# CITY PLANNING COMMISSION

- APPLICATION:**
- A. Negative Declaration
  - B. Special Permit to allow the construction of a 16,992 sq. ft. warehouse/office building in the Light Industrial/Planned Unit Development (M-1)(S)-PUD zone and Norwood Tech PUD.
  - C. Variance to allow for off-site parking and maneuvering on adjacent parcel.

**LOCATION:** Northeast corner of Research Drive and Opportunity Street

P87-455

**SITE PLAN**

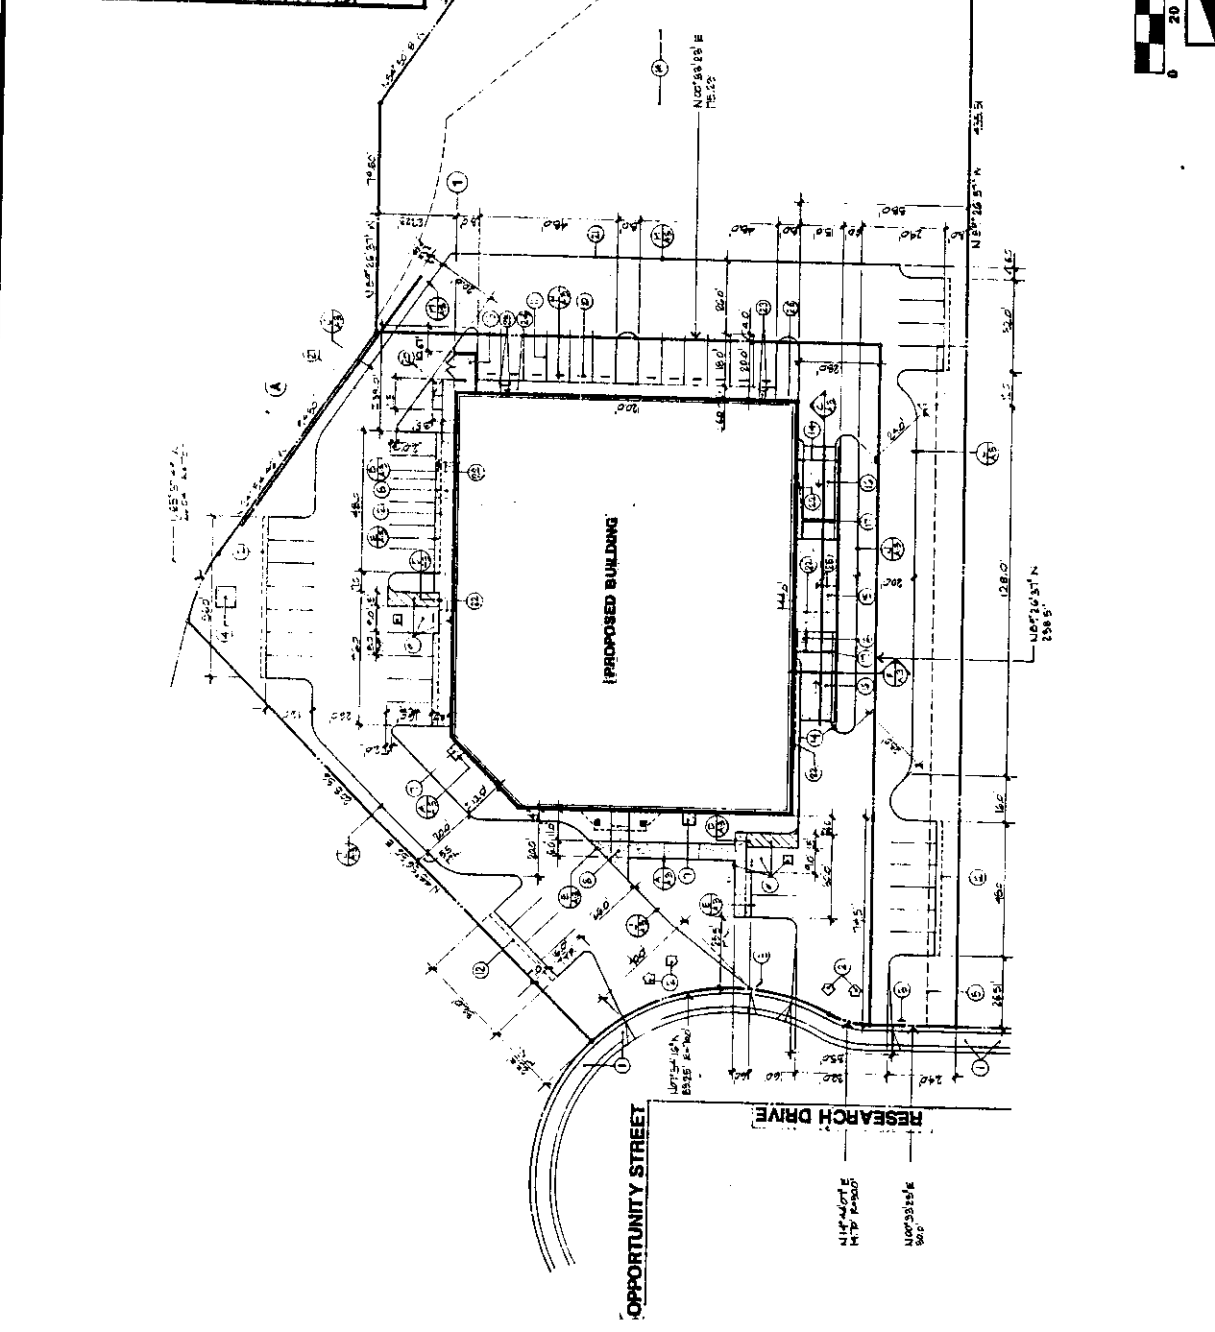
1. Landscaping: The submitted landscape plan indicates a 25.5 ft. front landscaped setback consisting of an undulating berm with turf and evergreen trees. Along the north property line, which is adjacent to the I-80 freeway off-ramp, a five foot planter is proposed. This planter will consist of ground cover and coastal redwoods planter at 25 ft. intervals along the entire northern perimeter. The southern property line is proposed to have an eight foot planter with ground cover and white alder trees at 25 foot intervals. A five foot planter with ground cover and trees is also proposed for the area just to the south of the loading dock area on the south side of the building. No landscaping is indicated on the landscaping plans for the east property line. Along this eastern side, the parking encroaches onto the adjacent parcel. Sod is proposed for a four foot planter between the parking area and the building. The undeveloped area to the east of the subject site should be maintained in a weed free condition.

Parking requirement for offices are calculated on the basis of one space per 300 square feet of office area within the warehouse; for warehouses, two spaces for each three employees, but in no event less than one space for each 1,000 sq. ft. of gross floor area for the first 20,00 sq. ft. Based on the above, the parking required for this project is 27 spaces. The proposed site plan indicates a total of 47 parking spaces. However, ten of these spaces are off-site and twelve require off-site maneuvering space. The applicant is requesting a variance for the off-site parking and maneuvering and has indicated to staff that a reciprocal access easement including an agreement which allows parking has been obtained. Staff has no objections to the variance. The additional parking is beneficial and will encourage less parking of service vehicles along the street. Staff recommends the parking of any service vehicles be located along the east building elevation, so as to minimize the visual impacts from I-80.

1. Driveways are to close, combine access or remove one and redesign - 35 ft. maximum width;
2. Reciprocal access easements required with adjacent parcels.

1. Construct standard improvements consistent with existing improvements.
2. Parking stalls to be 18 feet in depth.
3. North driveway will be radial to the elbow.
4. Maximum driveway width is 35 feet.
5. Obtain an reciprocal access easement to include an agreement which allows for parking, or
6. Merge lots or adjust lot lines, or

7. Lot line cannot split driveways.

1. A minimum 15 percent landscape coverage shall be provided and other landscaping shall comply with the Norwood Tech PUD Guidelines.
2. A minimum 25 ft. building setback from both the street and freeway is required.

- c. the projecting wing walls on the south side of building screening the loading dock area shall be extended in length.
6. The driveways shall meet the requirements of the Traffic Engineering Division.

7. The applicant shall submit a reciprocal parking and access agreement to the Planning Director prior to approval of final inspection of the structures by the Building Division.

**WEST ELEVATION**

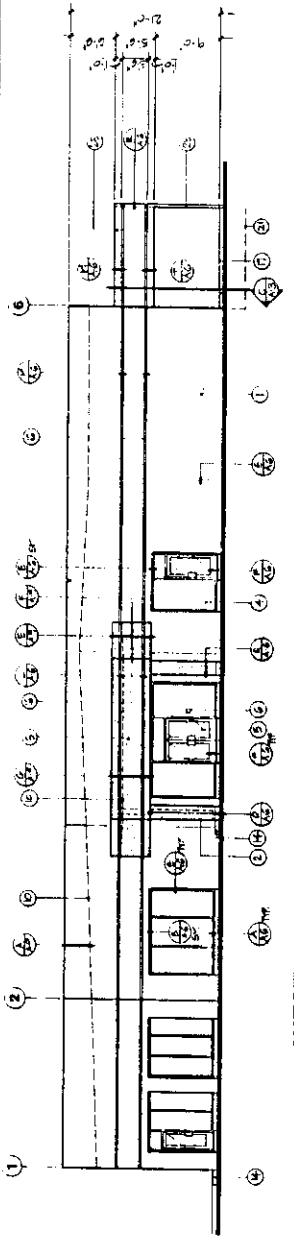
- on the north, east, and west elevations, brick veneer should be utilized as an exterior finish materials. This will greatly

enhance the aesthetic quality of the building and will make the building more compatible with the adjacent buildings to the west and south.

- window openings should be recessed along the north and west elevations to break up the flat building surface visible from the road ways.
- the projecting wing walls on the south side of the building should be extended in length to further screen the visual impacts of the loading area.
- trash enclosure structure should meet the trash enclosure guidelines.

- a. brick veneer shall be utilized on the north, east and west elevations;
  - b. window openings shall be recessed along the north and west elevations; and
